File 1994-0037

Name: Vista Del Norte – Final Plat – 27 ¾ Rd. and G Rd.

TITLE HEADING: Final Plat/Plan - Vista Del Nor'te

VISTA DEL NORTE  
FINAL PLAT/PLAN  
27 3/4 ROAD & G ROAD  
FILE #37-94

COMPOSITE PLAN  
**Vista Del Norte**  
 Subdivision

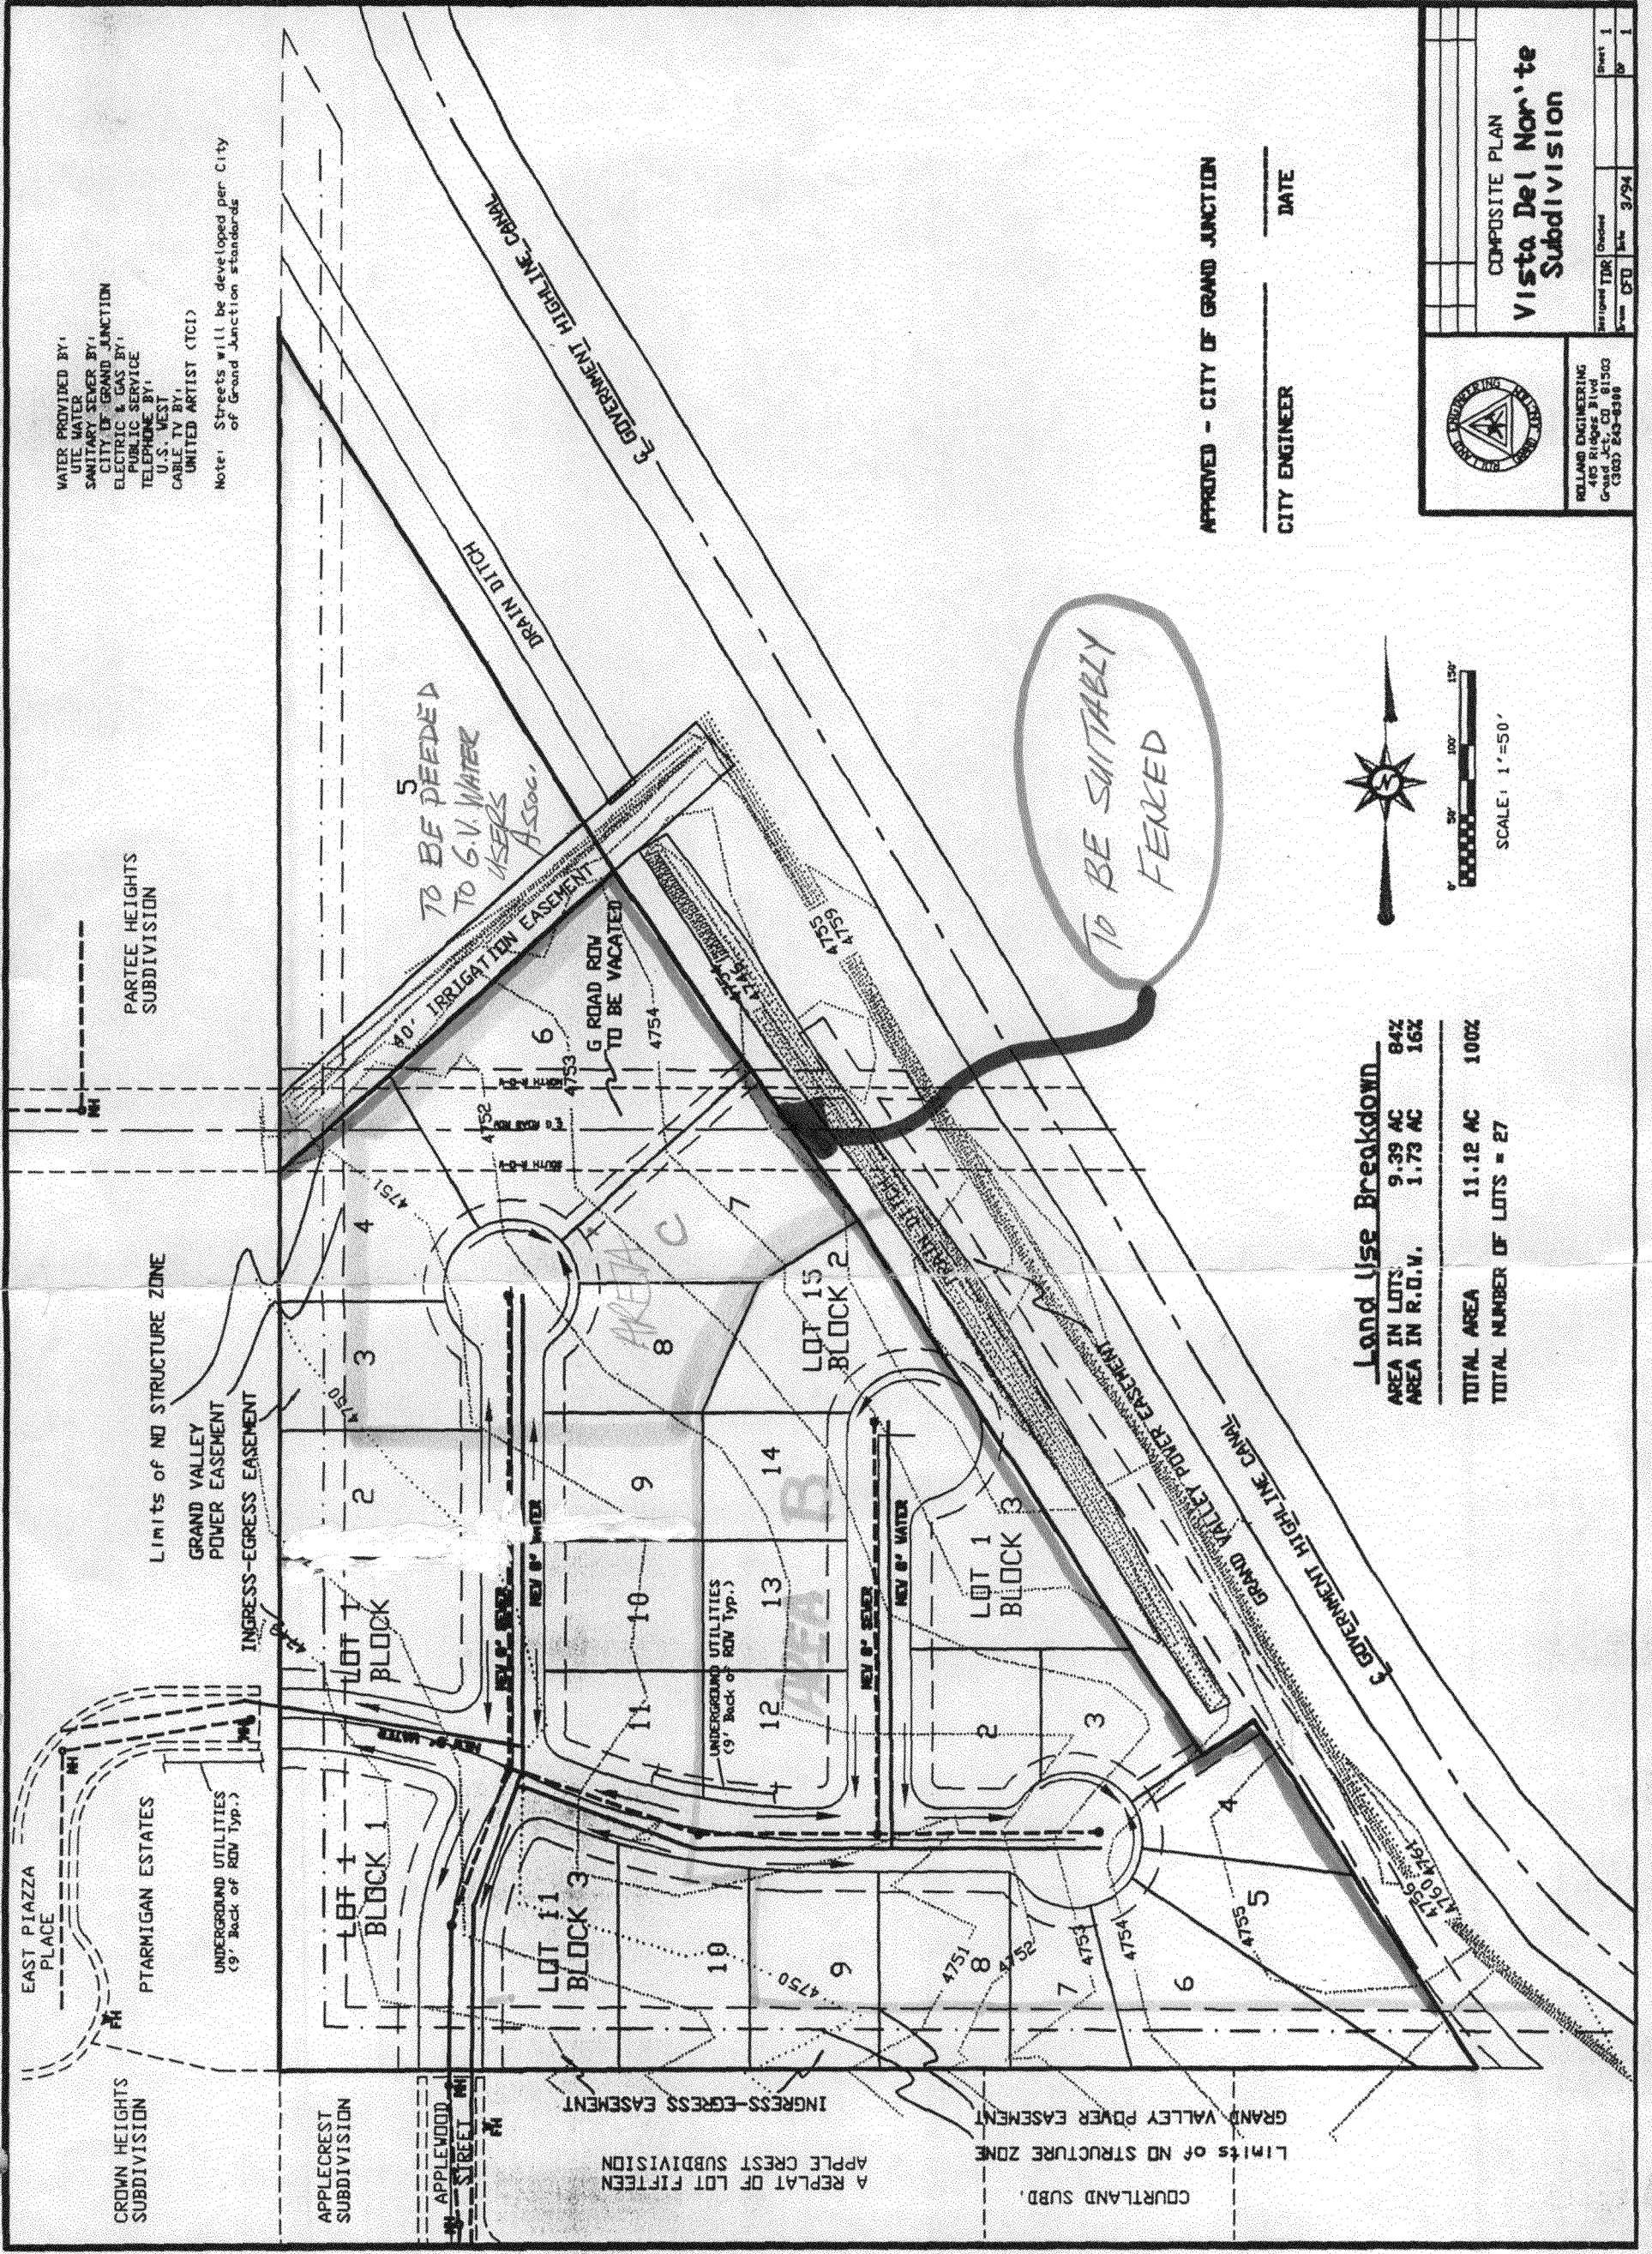
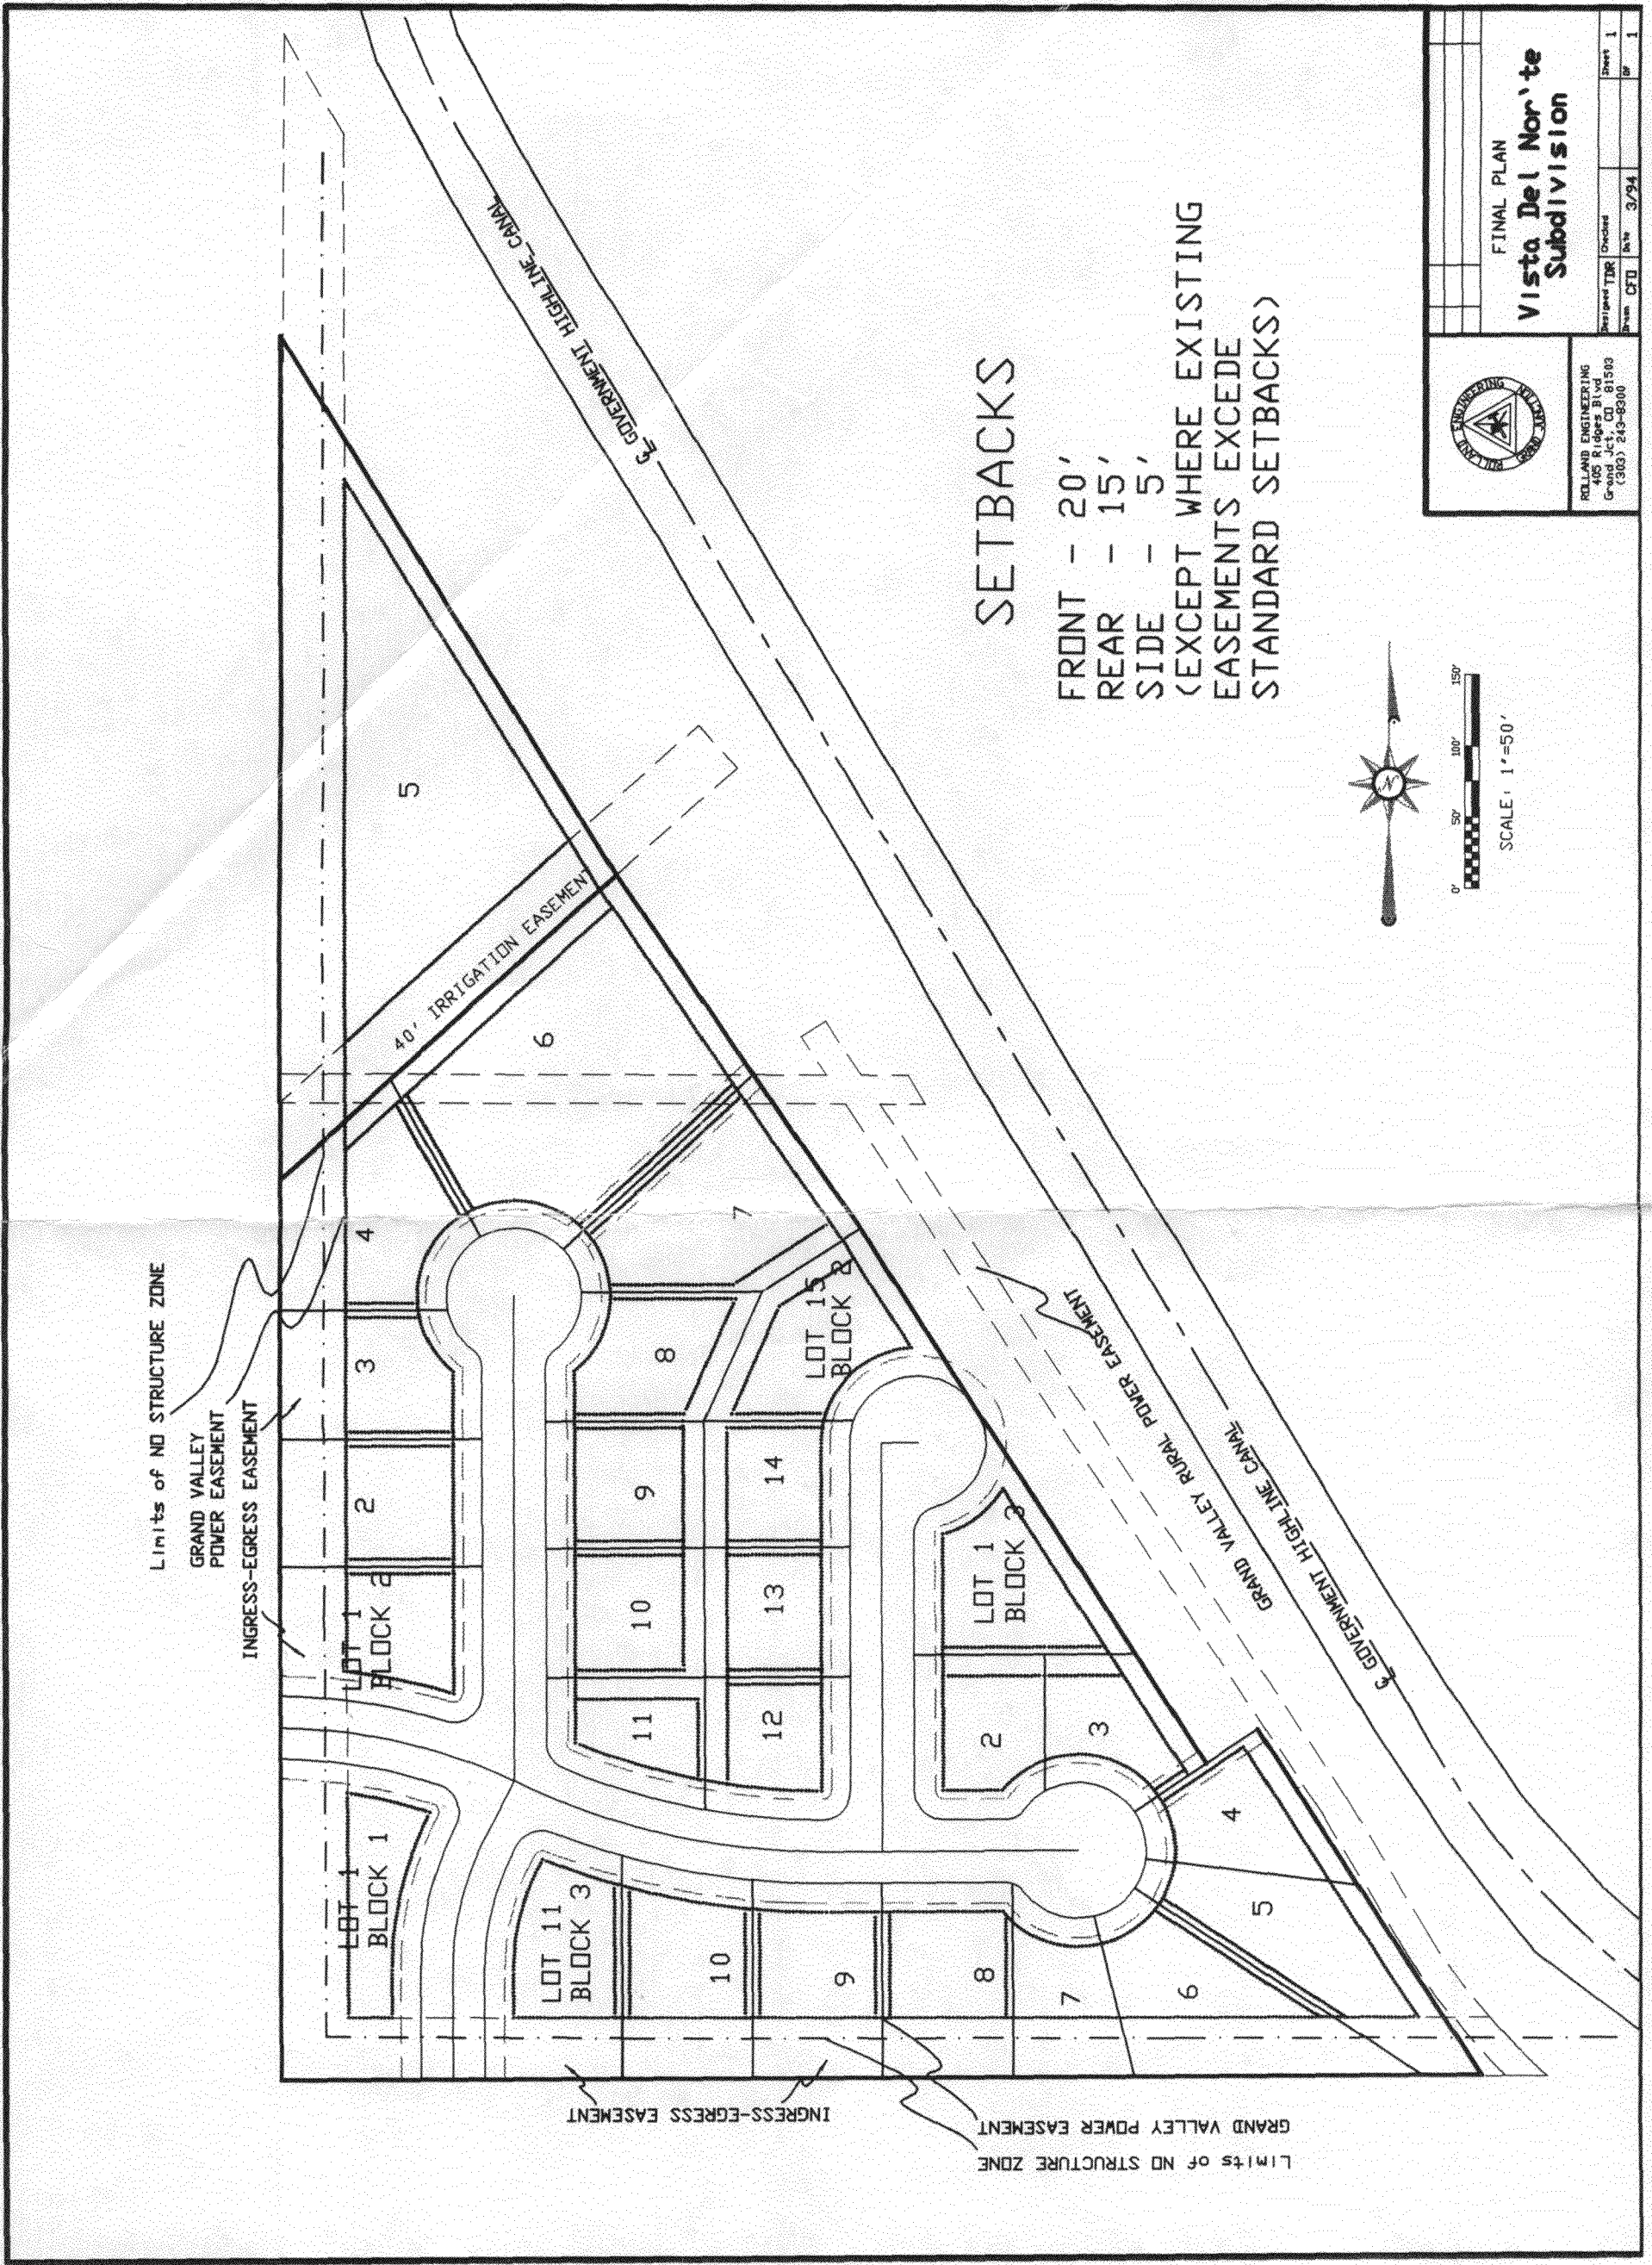
Composite plan does not specifically identify trails. We would like a map for our review prior to final approval.

Suitable fencing for safety, privacy, etc., along the perimeter of the subdivision adjacent to the drain ditch and canal on the east and an irrigation easement on the north will be a condition of the subdivision's approval by the Association. (See attached marked up composite plan).

City Parks and Recreation Department  
We have revised the Composite Plan to clarify trail easement locations.
